MEETING: REGULAR MEETING OF THE PLAN COMMISSION
DATE & TIME: Monday, June 9, 2025 at 6:30 PM
LOCATION: Germantown Village Hall Board Room
N112 W17001 Mequon Road

- V. **UNFINISHED BUSINESS:**
 - A. Parish Survey & Engineering, Agent for Matt Seban and TLC Acres, Property Owner W210N10738 Appleton Avenue. Site Plan Review for a 5,200 sqft building and a Conditional Use Permit (CUP) Application to allow grading & filling within a 25' wetland and 75' navigable waterway setback. (ACTION; Continued from April 28)

- VI. **NEW BUSINESS:**
 - A. Ken Frank, Agent for Home Path Financial, LP, and Mohrhussen Family Farm, LLC, Property Owner. Rezoning application to create the "Sutton Farm" Planned Development District (PDD) and Rezone 88.3 acres from the A-1: Agricultural District into the Sutton Farm PDD; and a Preliminary Subdivision Plat for an 88.3-acre residential neighborhood comprised of 171 single-family units and 102 multi-family units located at the northeast corner of Lannon Road (CTH Y) @ County Line Road (CTH Q) in the Lannon Gateway Neighborhood. (PUBLIC HEARING & ACTION)

C1.10

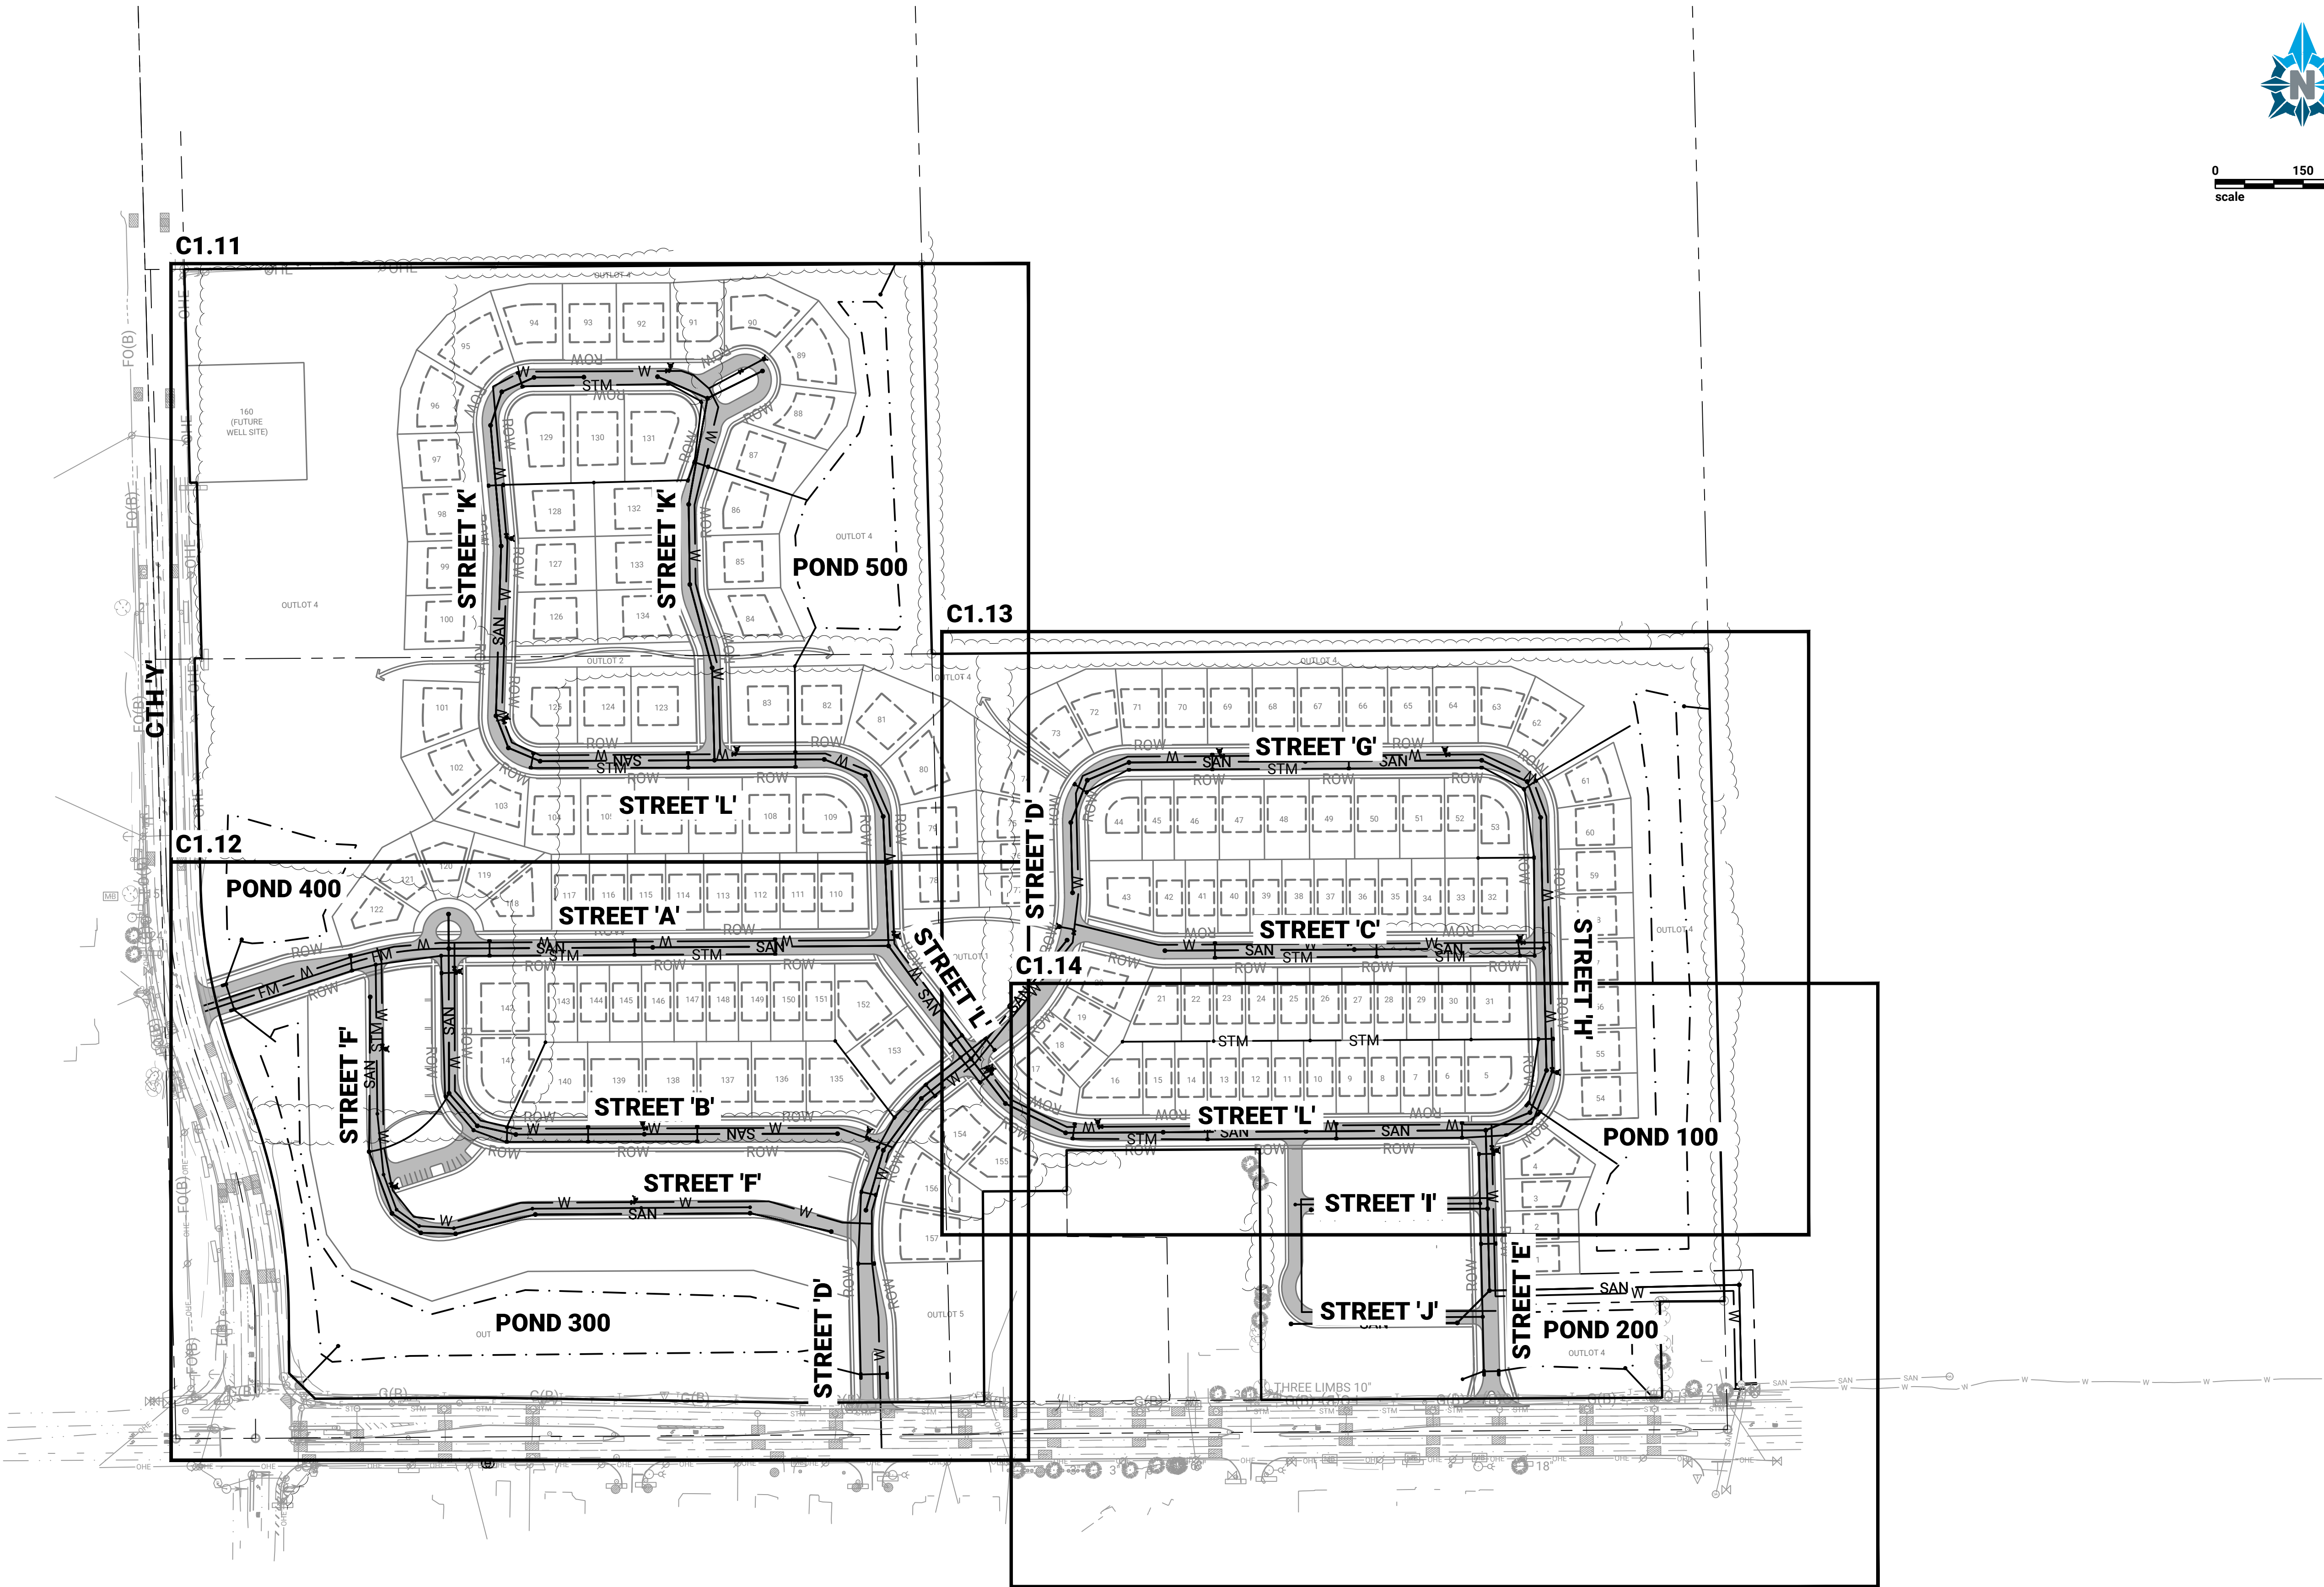
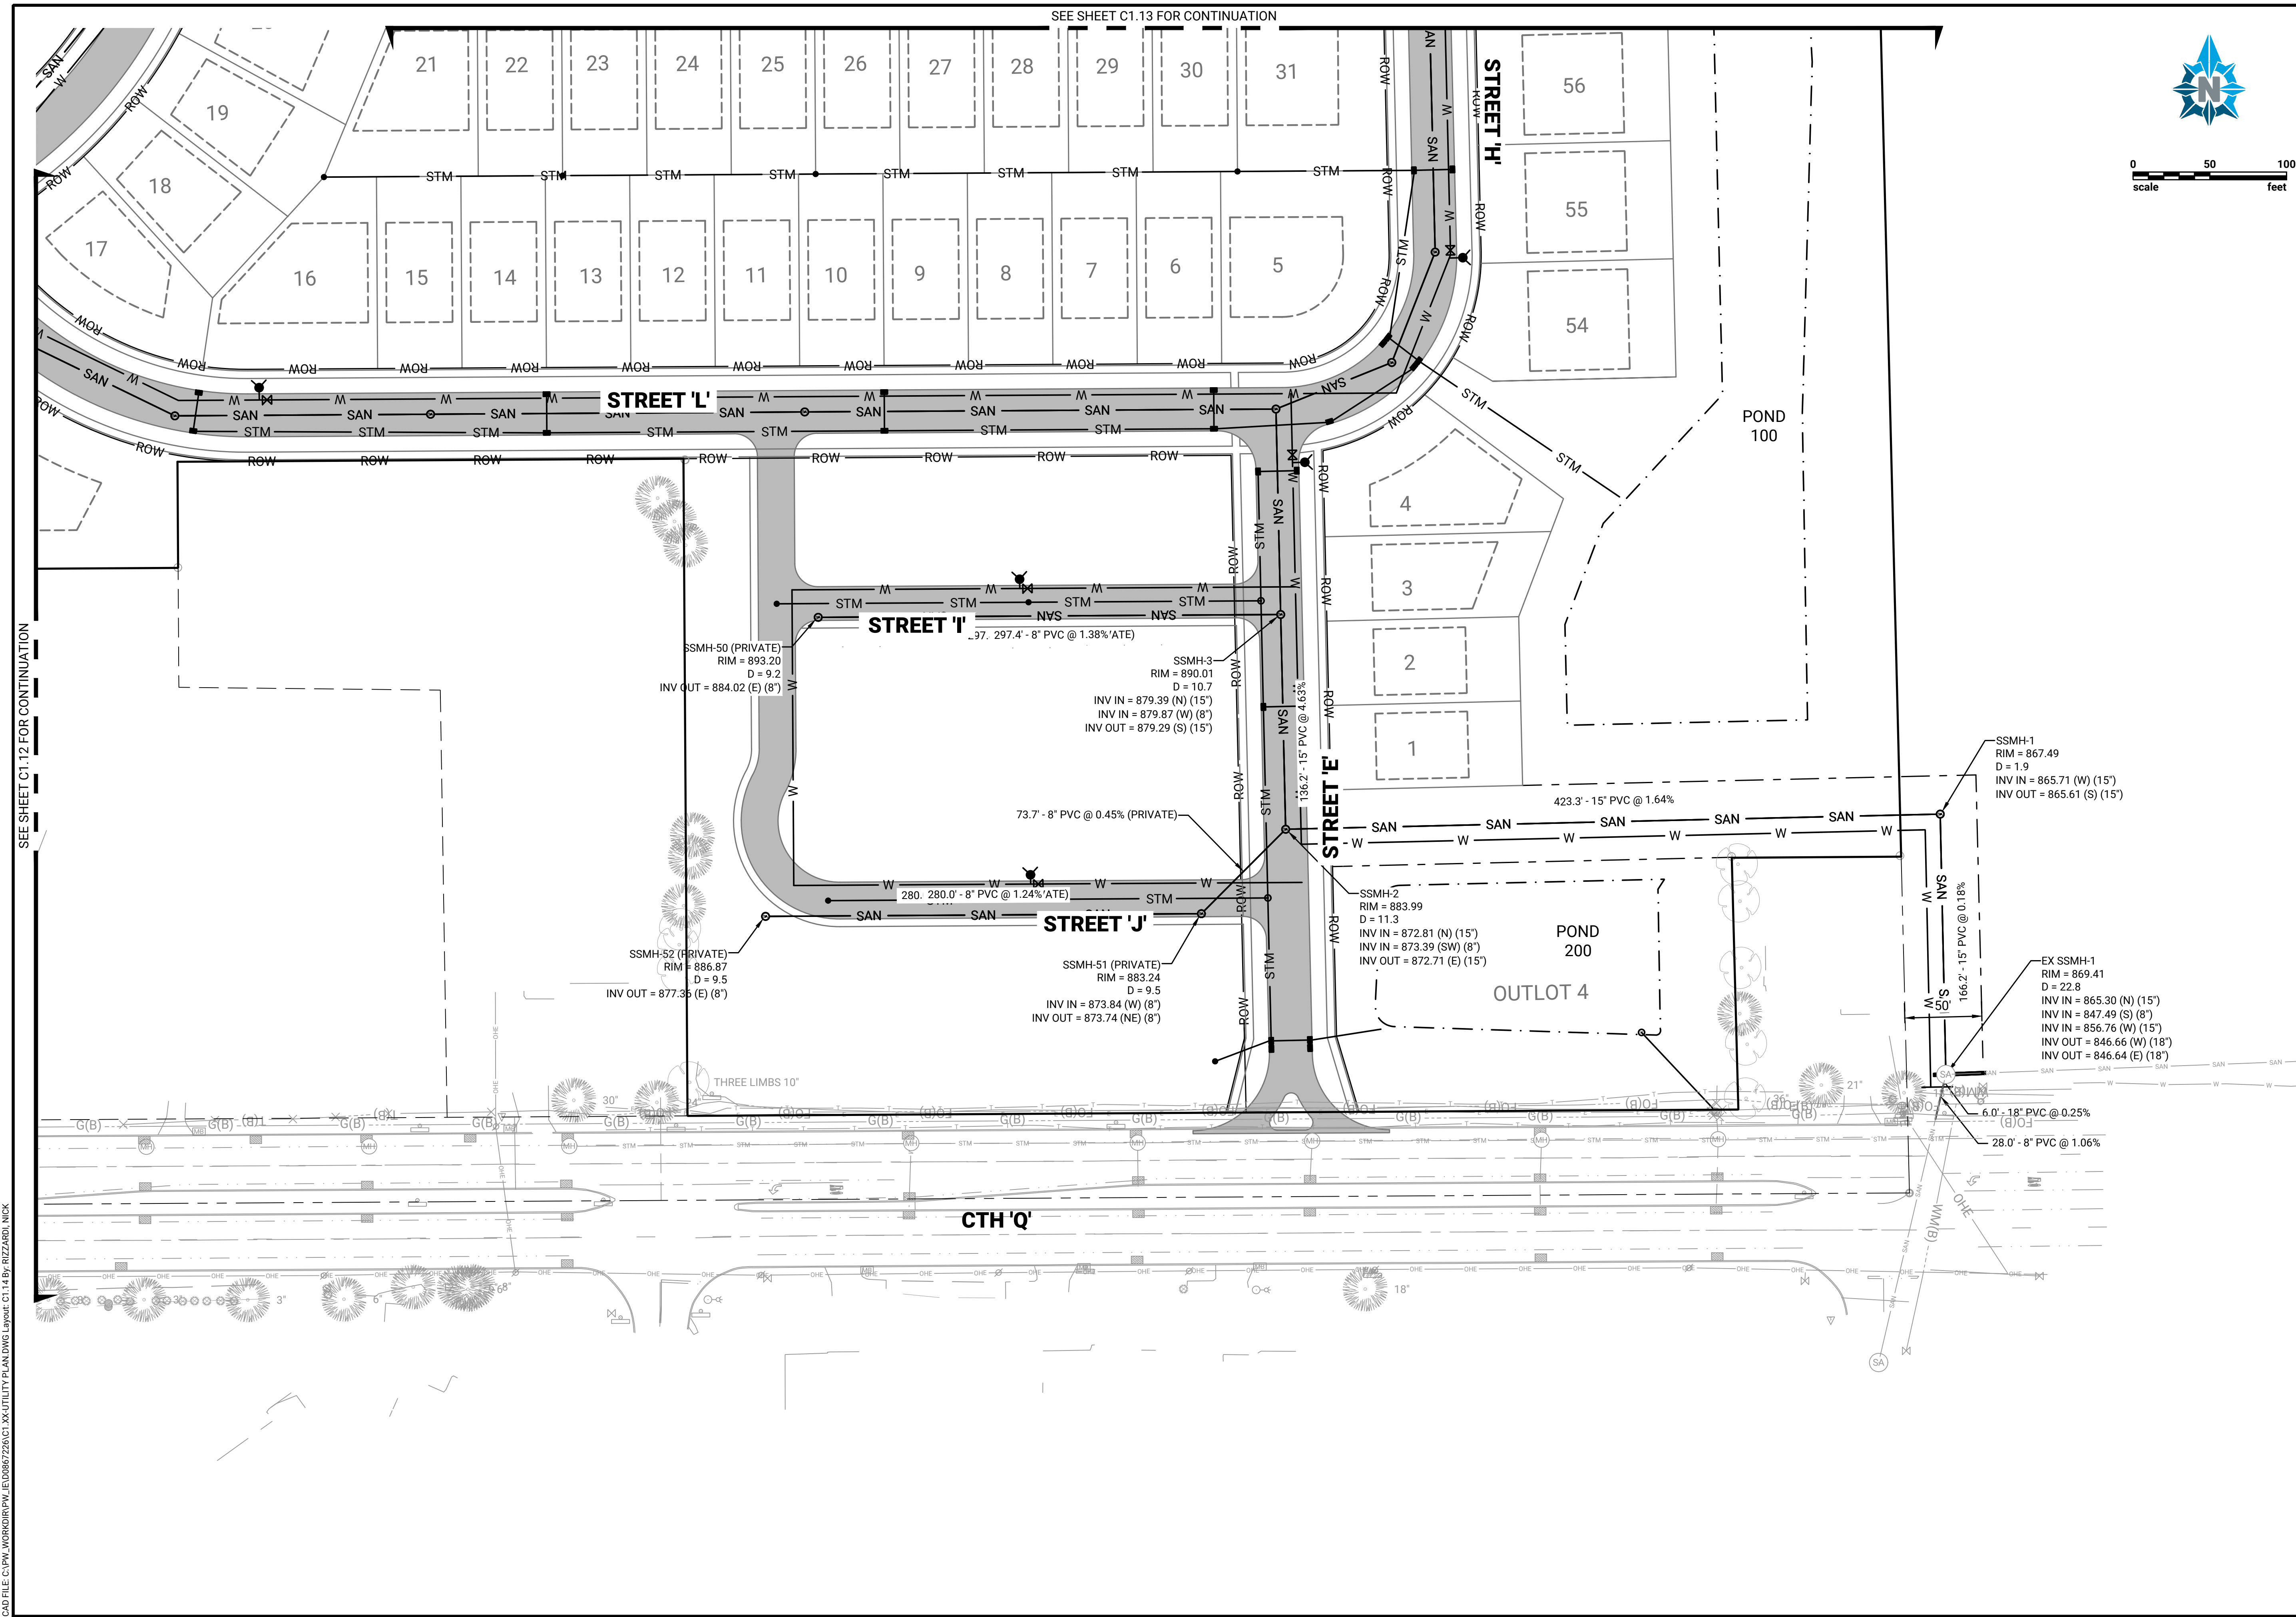
- Identify where utility easements would be required.
- Sanitary Building Sewer Laterals missing. Provide table with footing clearances.
- C1.11 – show offset clearances from sanitary to water main

DESIGNED: NCR	DRAWN: CJZ	CHECKED: CDH
PROJECT NO.: 0025H025.00		
PRINT DATE: 5/30/2025		
SHEET NO. C2.04

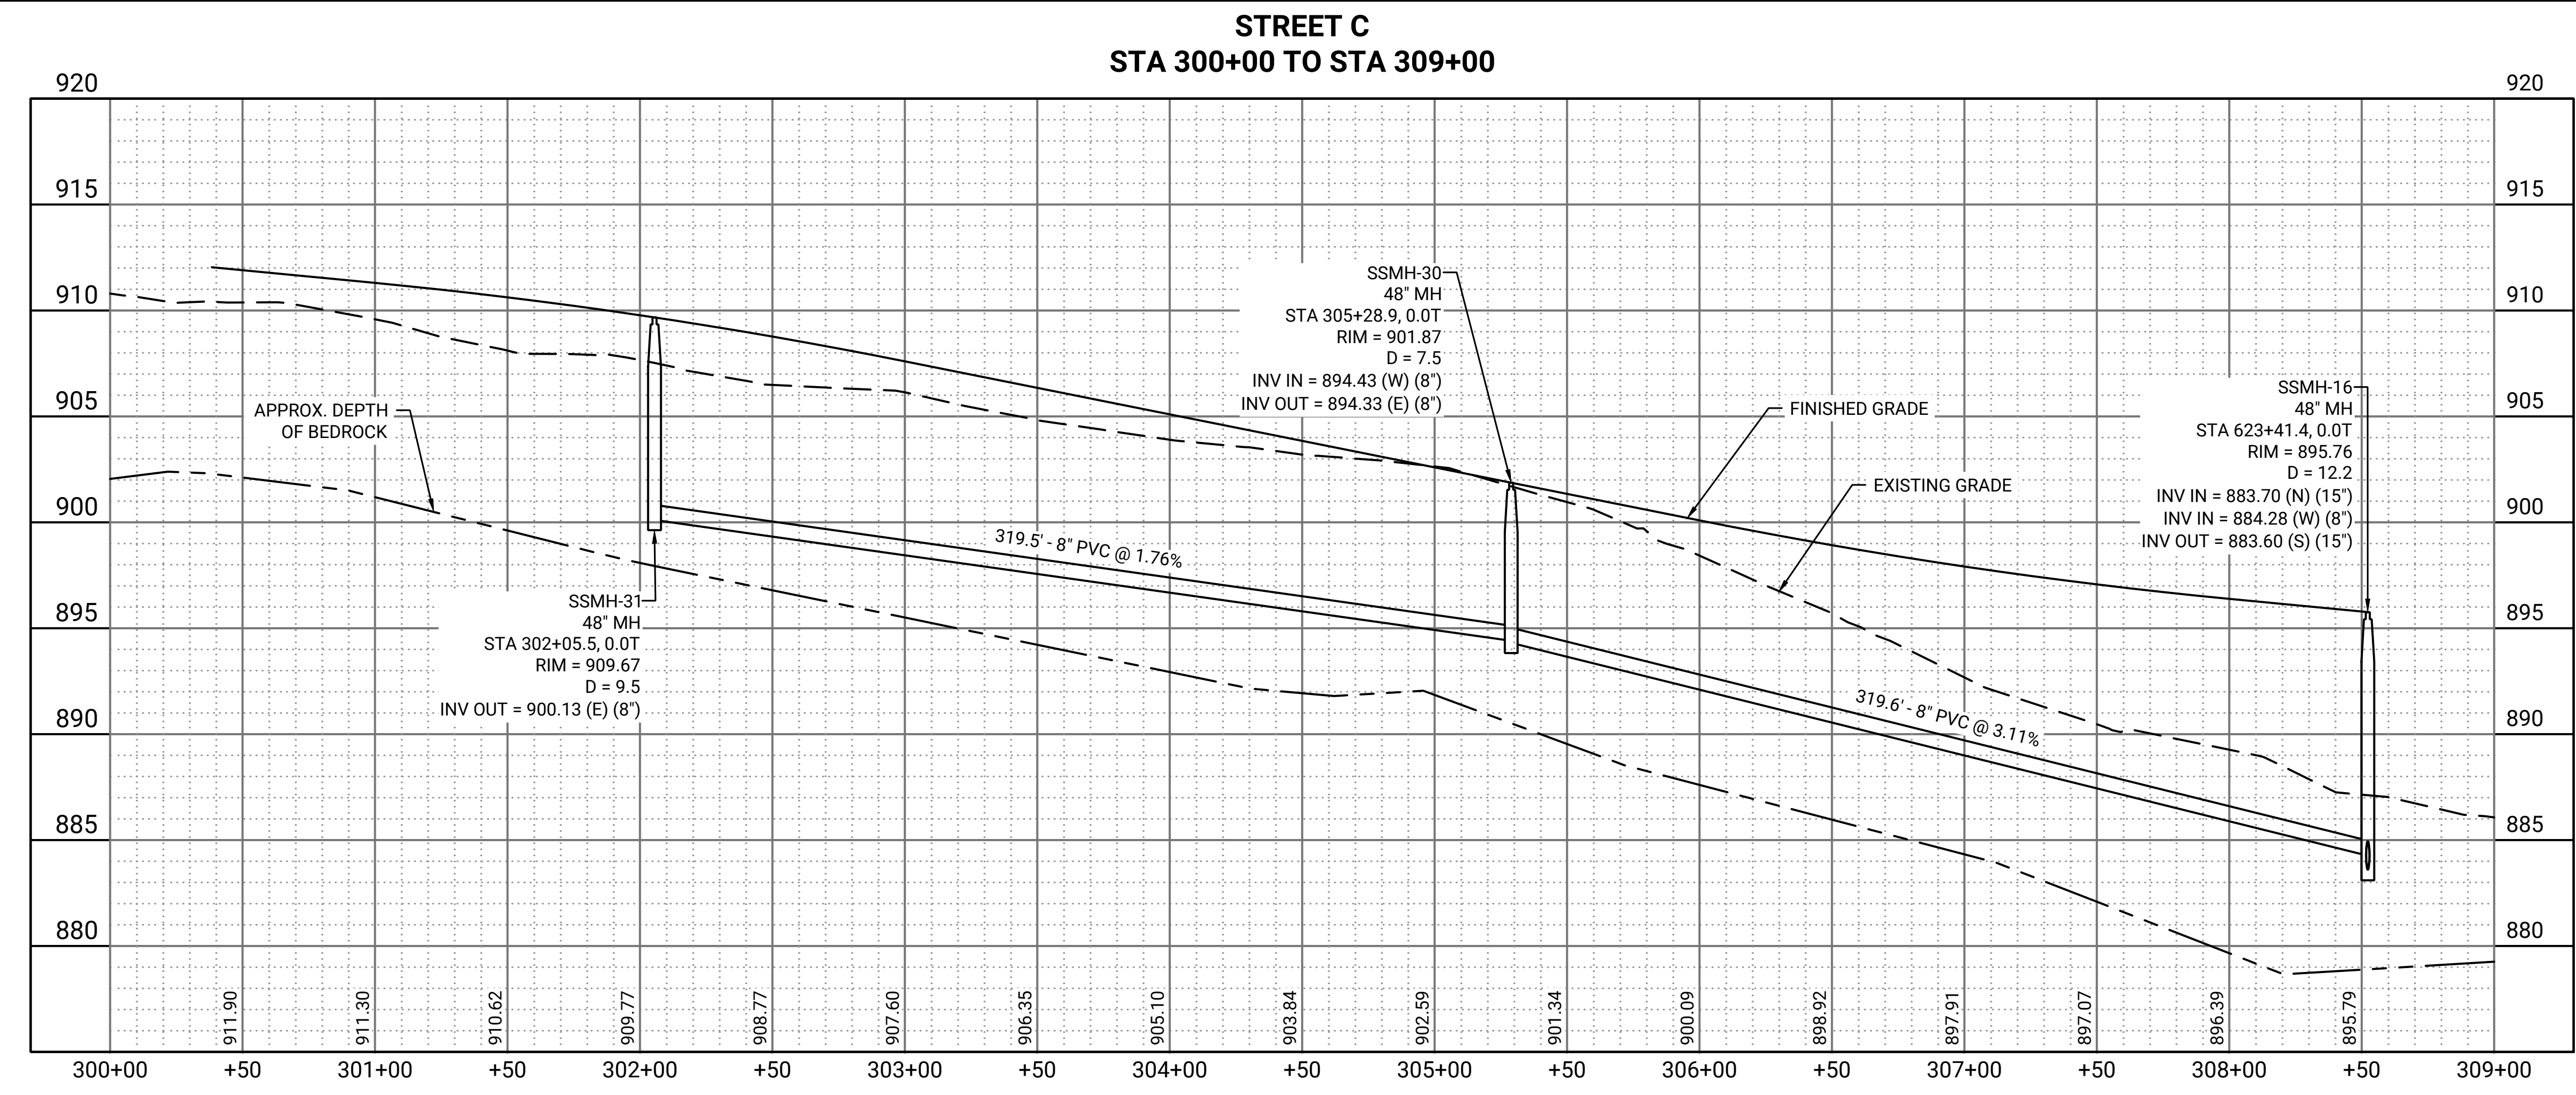
- C2.03 - Add SMH as Street D along avoid secant/tangent alignment outside of roadway. No storm in centerline.
- C2.04 – Sanitary slope 4%. That is steep. Clarify what is design velocity.

- C2.04 – Show vertical clearance in profile between sanitary and water near Street L and Street E.
- C2.05 – 5ft of cover is not accepted per the Development Handbook: 3.1.1.2.9 Minimum sewer depth shall be 8 feet from finished grade to top of pipe, except under exceptional circumstances and approval of Village Engineer. Sewer depths shall provide gravity flow for basement floor drains and plumbing fixtures.
